## PLANNING DEPARTMENT STAFF REPORT AND FINDINGS

### ROLLING MEADOWS SUBDIVISION PHASES 6, 1<sup>st</sup> Addition – PRELIMINARY APPROVAL (File SUB-24-36)

#### **Preliminary Subdivision Plan Map**

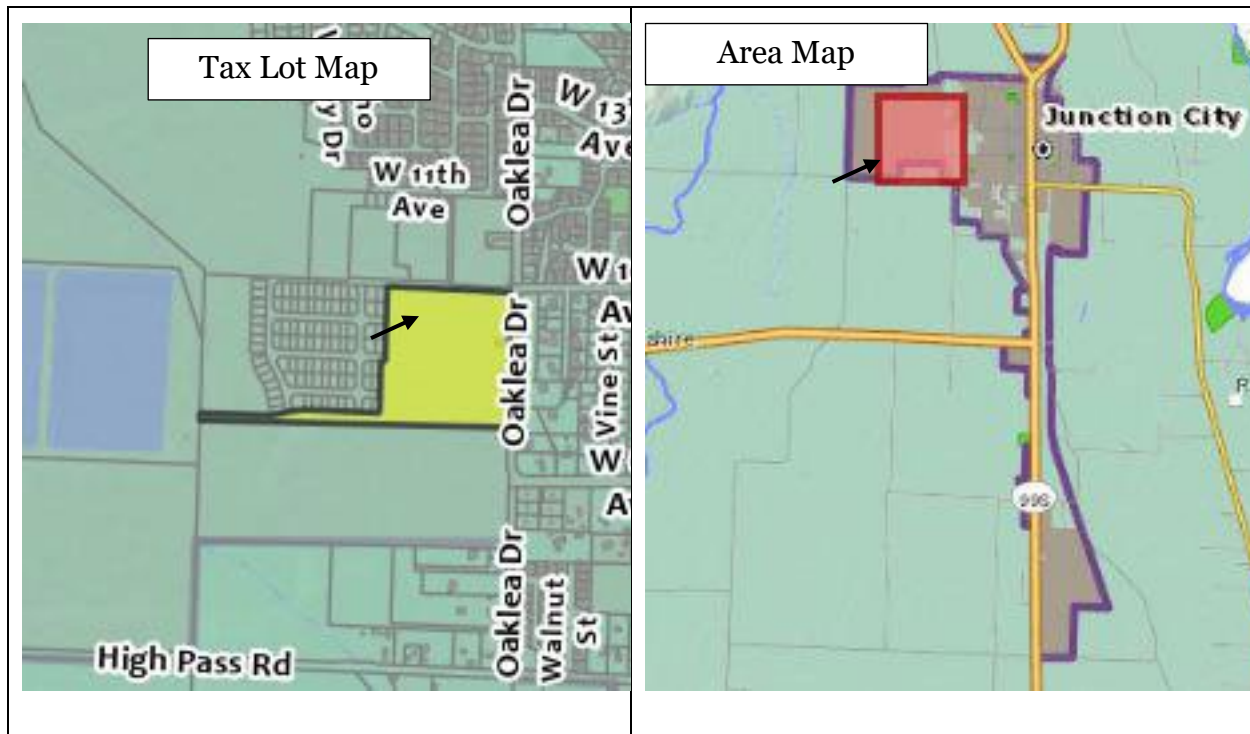
As noted above, the applicant has proposed to divide 0.81 of the 7.84 acres into 10 residential lots of medium density, and leaving the other ~7 acres for future Additions of Rolling Meadows Phase 6 (see Attachment 1 for more detail):

According to the Tentative Plat, the proposed R2 zoned lots meet the minimum lot area and width requirements of 3,000 square feet and 34 feet lot width.

requirements were proposed. The tentative subdivision site plan shows adequate space for residential development on the lots zoned R2 with the required reduced setbacks in place.
